MIL-C-28748/7E
AMENDMENT 3
12 June 2000
SUPERSEDING
AMENDMENT 2
15 October 1993

MILITARY SPECIFICATION SHEET

CONNECTORS, ELECTRICAL, RECTANGULAR,
RACK AND PANEL, SOLDER TYPE PIN CONTACTS, SIZE 22

Insert with 34 contacts

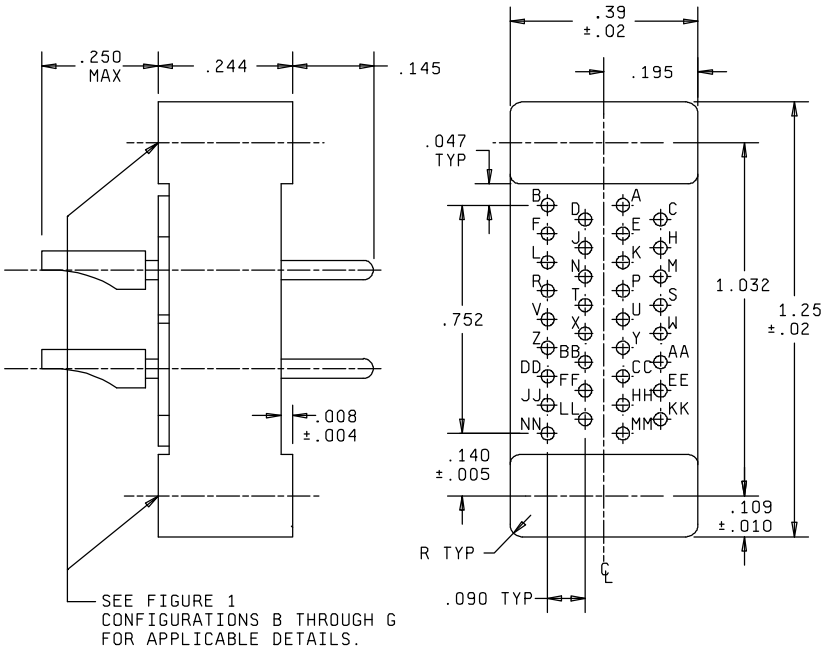
*FIGURE 3, configuration F, delete and substitute as follows:
